MEMORANDUM

Date: December 14, 2018

From: David Revell, PhD

Subject: Huntington Beach Desalination Review of Sea Level Rise Hazards

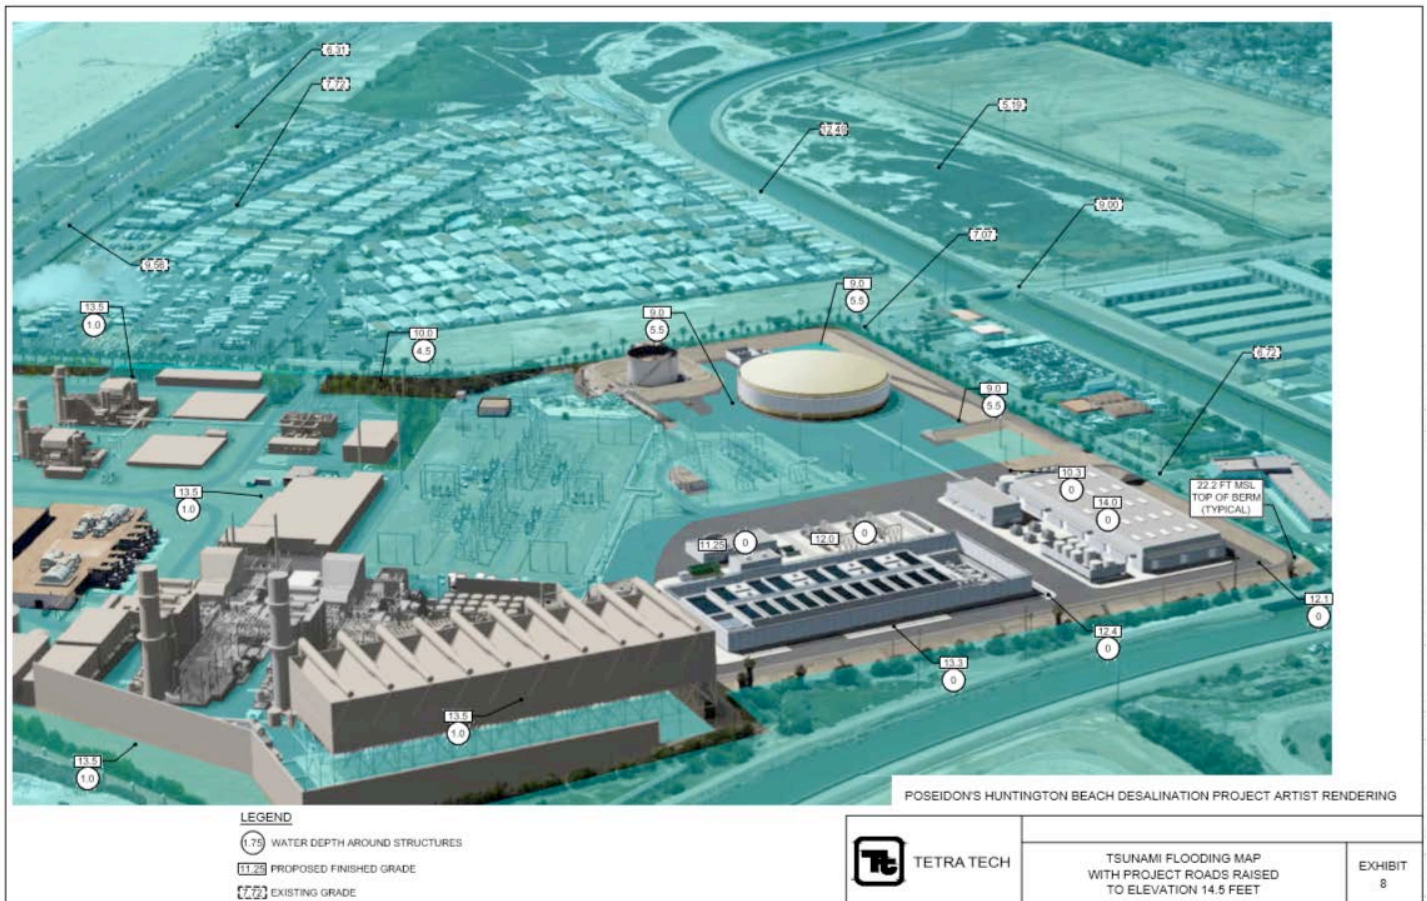
The proposed site currently has several rings of oil spill containment berms. As part of the project, the internal and south-facing containment berms would be demolished and the exterior berms on the north side of the site would remain. The outer berms have an average crest elevation of 24.8 feet NAVD (Tetra Tech, 2016) (Figure 3). The project description mentions all internal roads within the site will be raised to an elevation of 14 feet NAVD (M&N, 2017), and ground floor elevations for proposed structures would range from 10.6 to 16.6 feet (Tetra Tech, 2016). Outside of the project site, the road elevations on Edison Drive and Newland Street would likely remain the same. Additionally, the top of the Huntington Beach Channel Wall is about 13.1 – 13.3 feet for the stretch adjacent to the project site. Across the PCH, beach berms for Huntington Beach vary between 12 and 15 feet, with 13 ft being typical. It is unclear if there are any proposed changes in the distribution network which will likely be more exposed in the future.

Past coastal hazard models are all based on elevation data from 2009-2011. At these times, all surrounding containment berms were in place. Current site plans indicate that there will be an opening in the berms from Edison Drive on the north, and from the entire south ocean-facing side. This, in addition to the changes in grading, make interpretation and use of previous coastal hazard models difficult.

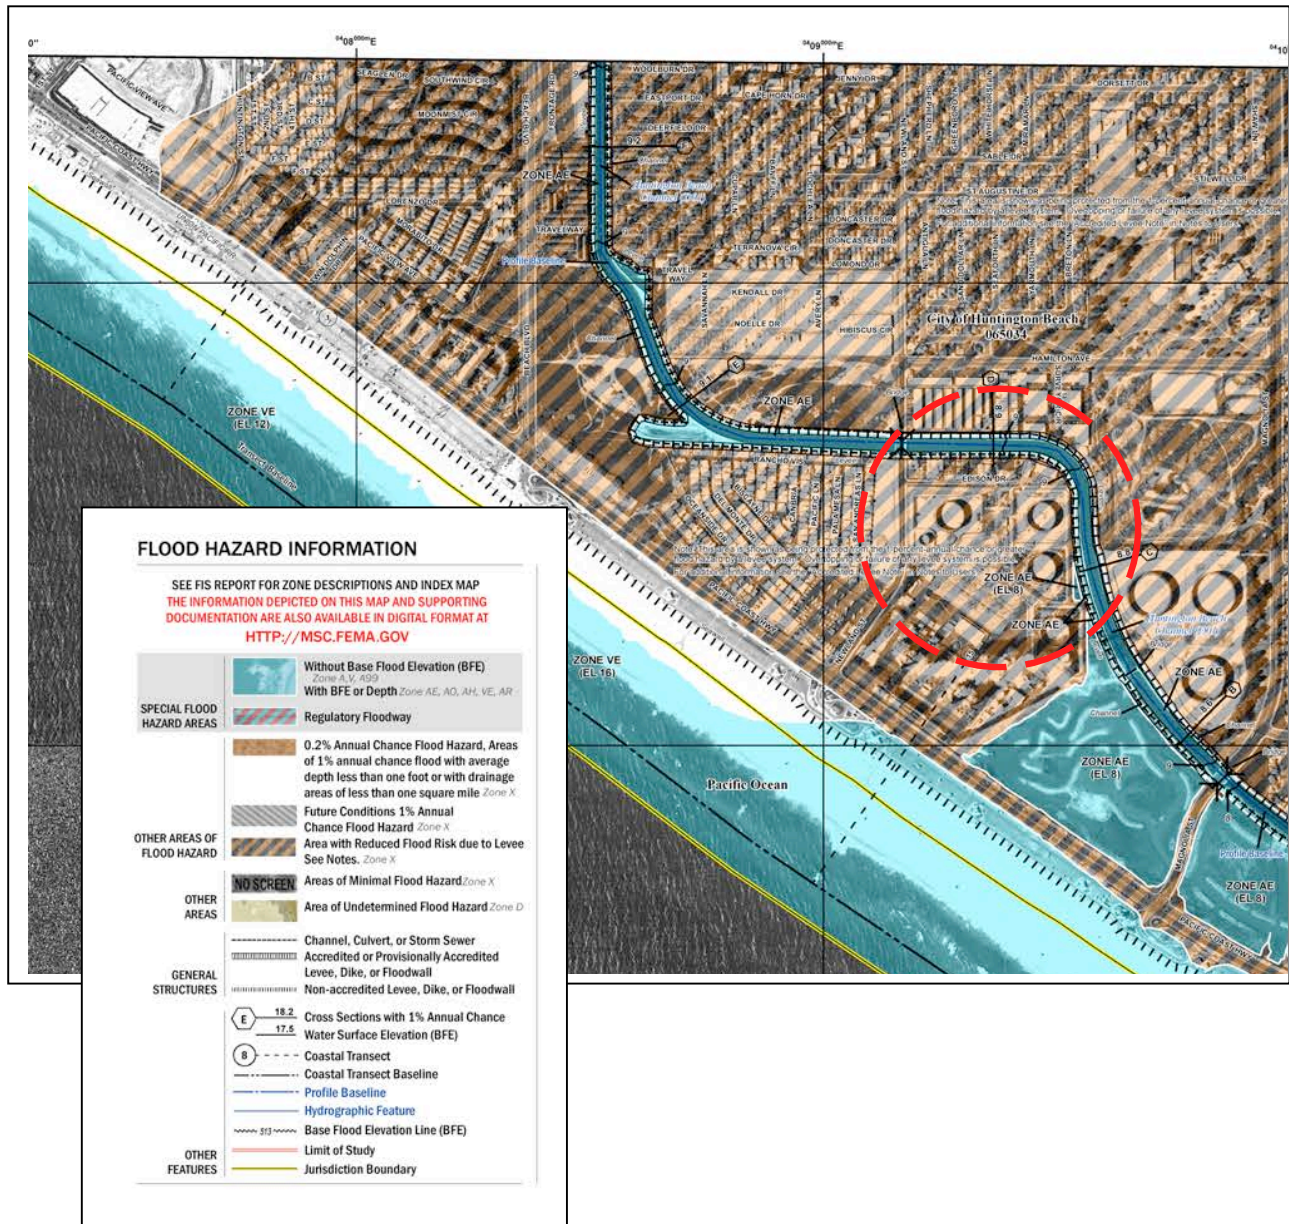
According to the Effective FIRM (Panel 06059C0263J effective 12/3/2009, Revised via LOMR for the site 09-09-281P certified 12/15/2009), during a 100-year river flood, the flood water level in the Huntington Beach Channel is estimated to reach +9 feet NAVD (FEMA, 2009). This corresponds to data from the adjacent Huntington Beach wetlands that show a 100-year flood elevation of between 9 and 10.2 feet NAVD (M&N, 2014). The existing 500-year flood hazard shows inundation at the site and is identified as being in “Zone X” with flood depths of less than 1 foot. Flood protection at the site is influenced by tides, as flood waters are released more slowly during high tide and flow into the flood control channel and surrounding wetlands. It can be anticipated that flood extents and depths on this tidally influenced channel will rise in elevation with rising sea levels.

FEMA identifies the site as being located in “Zone X”, which is a designation for an area that is protected by certified flood control structures from a 100-year storm, but is within the 500-year Flood Zone. The site is also identified as being within the Prado Dam Failure Inundation Zone, a zone established by the City of Huntington Beach (Michael Baker

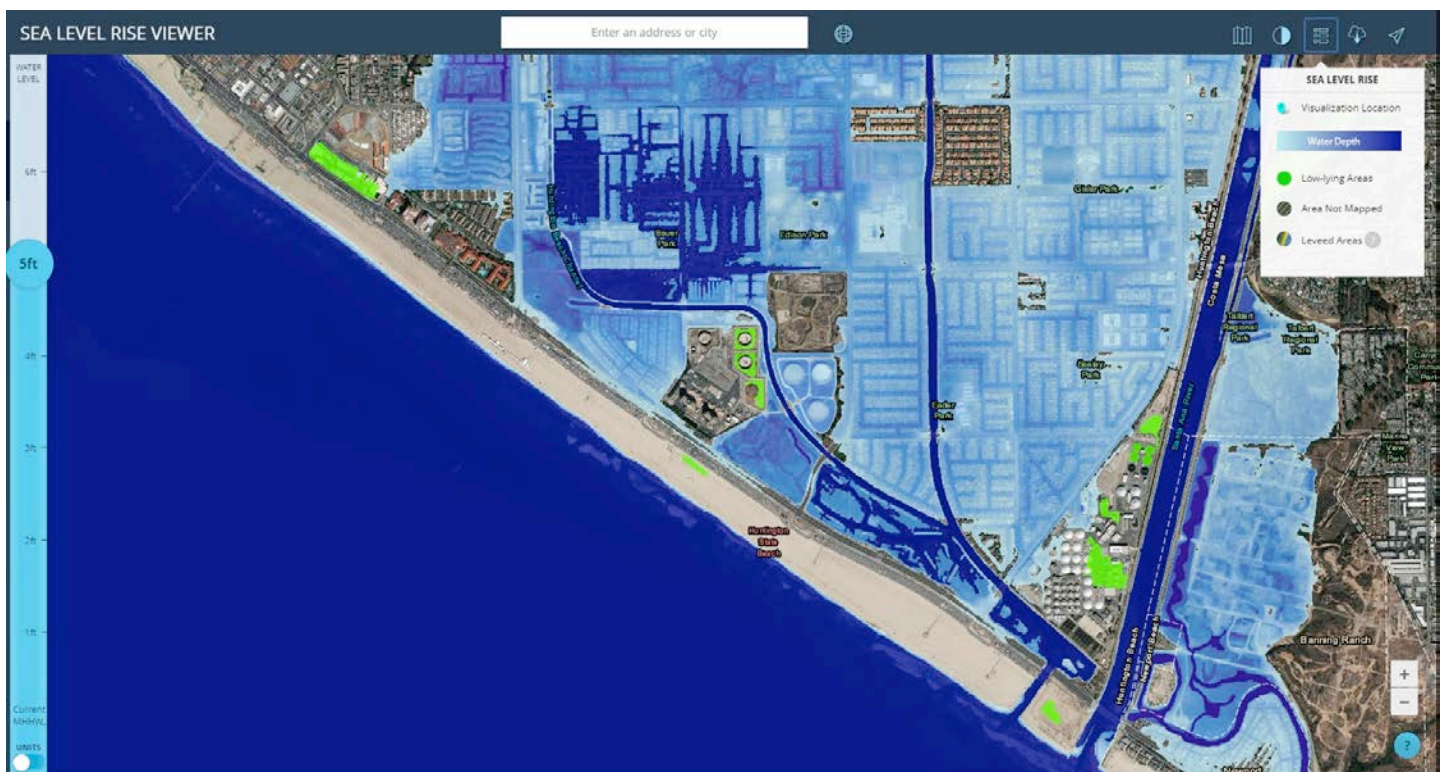
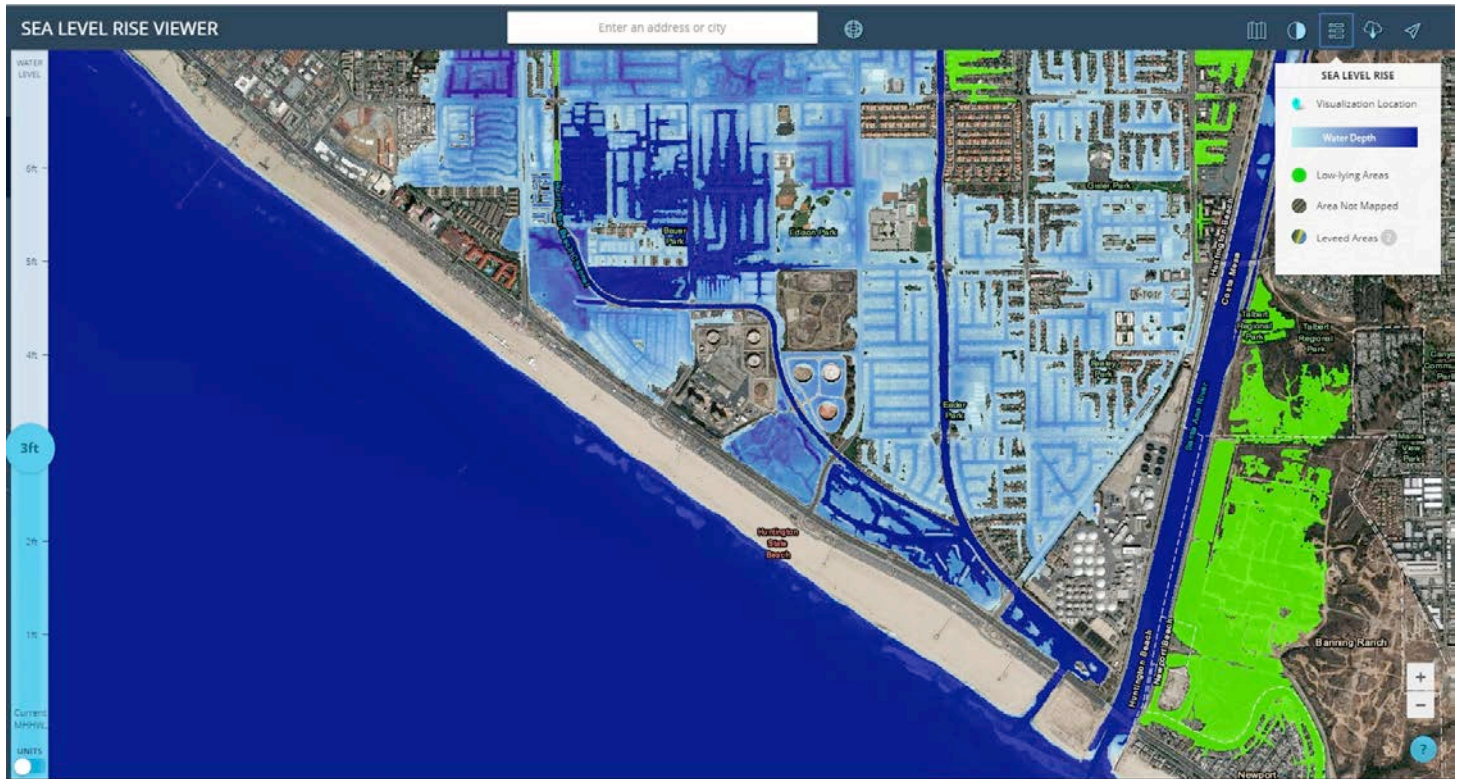
The NOAA SLR viewer maps a MHHW (5.29' NAVD) flood extent with up to 5' feet of SLR on the existing topography, which could occur as early as 2070 under the H++ scenario (figure 6(B)). The map shows that under existing conditions and 3 feet of SLR, the site is relatively safe from flooding (figure 6(A)). With 5 feet of SLR, the three eastern most oil storage tank sites could be inundated if hydraulically connected, and with 6' of sea level rise, all of the tanks could be flooded. However, a current king tide is nearly 2 feet higher than MHHW, meaning that under existing topography, Figure 6B flooding could occur a few times a year with only 3 feet of sea level rise.

Results of the tidal inundation mapping show relative depths in the shades of blue which don't appear to affect the site. Shades of green are low-lying areas where, if hydraulic connections exist (e.g. via a culvert or gap in containment berms) beyond the resolution of the model elevation grid, those areas could also be flooded. This indicates that the existing berms are serving as flood protection under these conditions. The green could also indicate areas that could be flooded through daylighting groundwater if the duration of those tide waters is sufficient. An in-depth analysis on daylighting is provided in a following section.

Figure 7 (A). Wave run up flooding from a 100-year wave event and 5 feet of sea level rise. (B). Wave run up flooding from a 100-year wave event and 6.5 feet of sea level rise. Site identified in red circle.

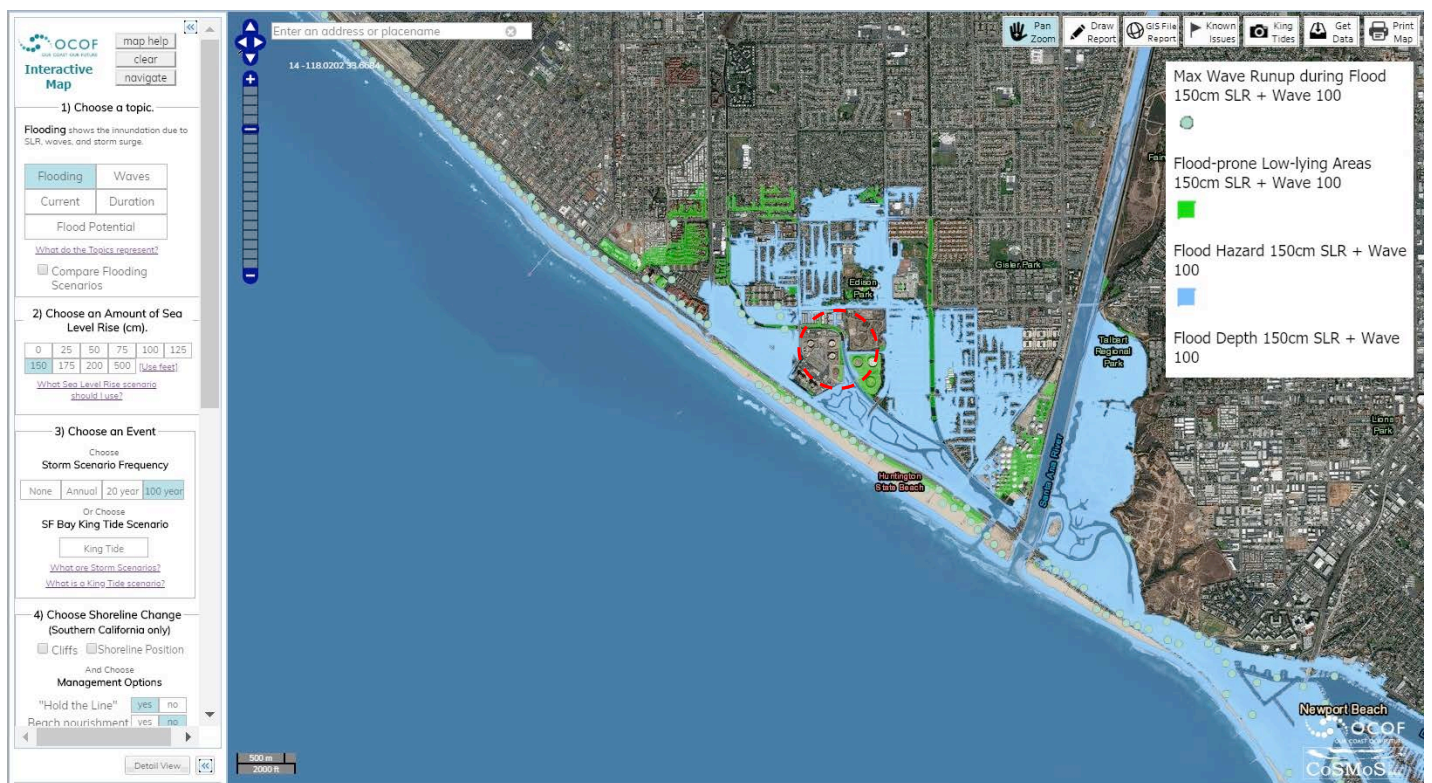
Results of the CoSMoS 3.0 model do not show much sustained coastal wave flooding to the site with up to ~5 feet of sea level rise, even with current low elevations. However, maximum wave run up does show that waves could run up to inland areas beyond the proposed site, potentially impacting access to the proposed facility (Figure 7A). With 6.5 feet of sea level rise, the site could be expected to be impacted by sustained flooding across most of the site, and maximum wave run up extents could extend over 2 miles inland. Flood depths at the proposed site for existing topography show potential flood depths of 0.8 feet to 3.4 feet with ~5 feet of sea level rise and 1.5 to 4.1 feet with ~6.5 feet of sea level rise. The range in flood depths are based on model uncertainties. Results of the model also show that the existing berms would provide some level of flood protection under this scenario.

There are some apparent issues with the CoSMoS 3.0 results. First, the model does not account for flood control channels on Talbert Channel or Huntington Beach Channel, nor does it account for the existing hydraulic connection across the beach under the bridge on the PCH. It is also not entirely clear why wave run up at one transect would not get the beach wet during a 100-year wave event and 6.5 feet of sea level rise, yet on the adjacent transect wave run up could travel 2 miles inland. The variability in these model results do call into question the vulnerability to wave run up at the actual site.

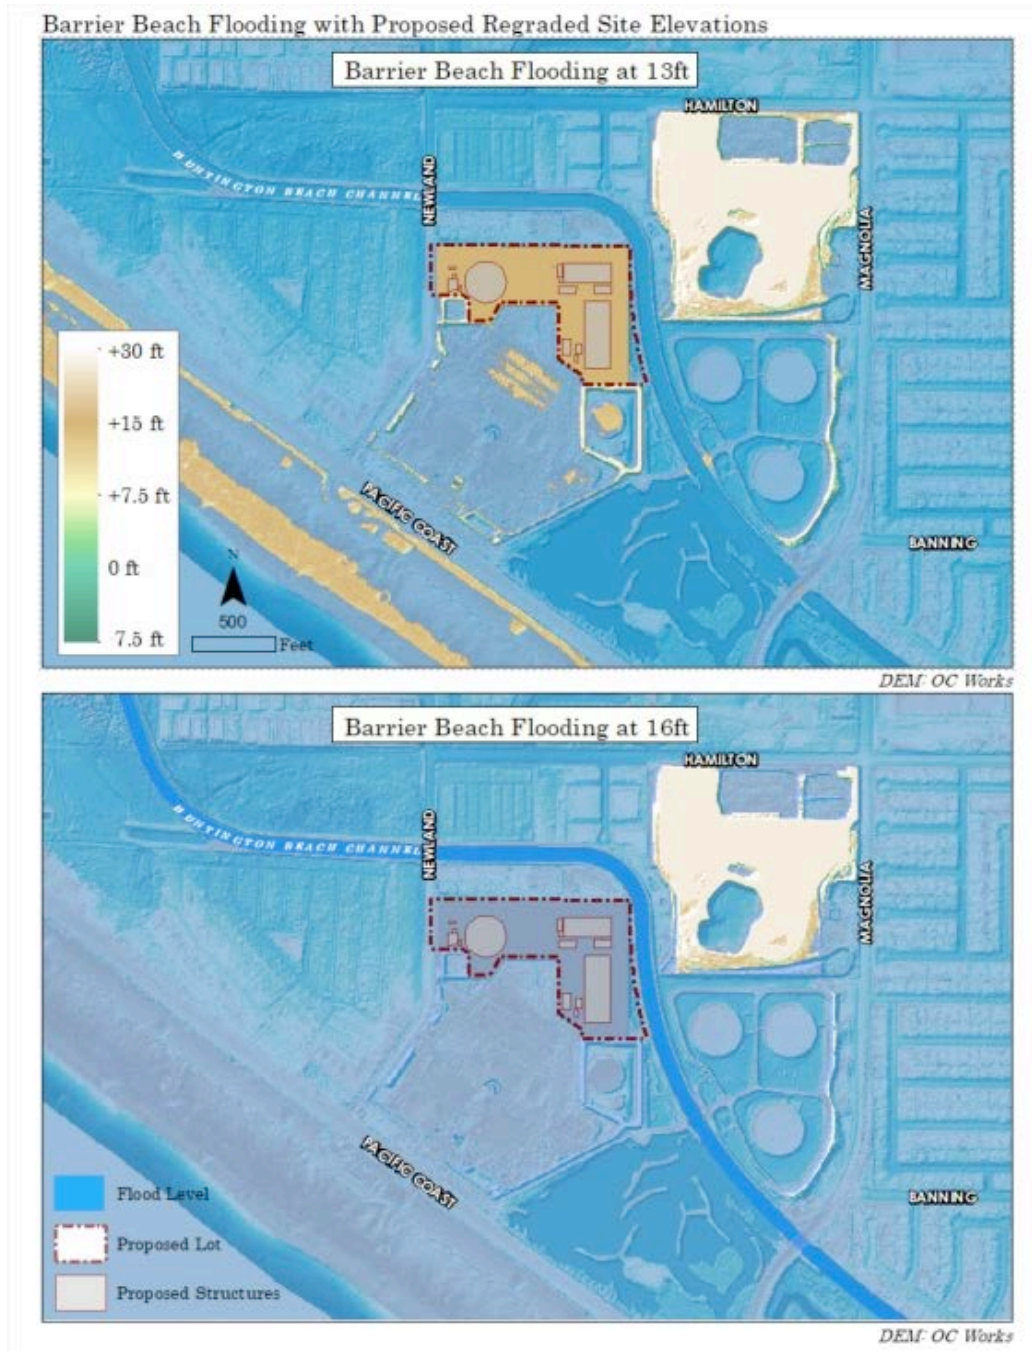
The Huntington Beach Channel and the Santa Ana River were all historically bar built estuaries which meant that the sand berm fronting the estuary would open and close seasonally in response to wave energy and river flows. When the beach berm closes, water fills the channel/estuary like a bath tub to the elevation set by the beach berm crest. By evaluating available topographic data for the nearby beach berm crest during late summer/fall conditions, it was determined that the berm crest elevation routinely reaches between 12 and 15 feet NAVD. Assuming a beach berm crest of 13 feet was reached and not artificially breached, then barrier beach flooding today could potentially reach the top of the existing flood control channel. With any amount of sea level rise, this closed barrier beach flooding could overtop the Huntington Beach Channel and potentially inundate the proposed site. Considering proposed regraded site elevations, any amount of sea level rise over 1 foot could inundate the proposed facility site (Figure 8).
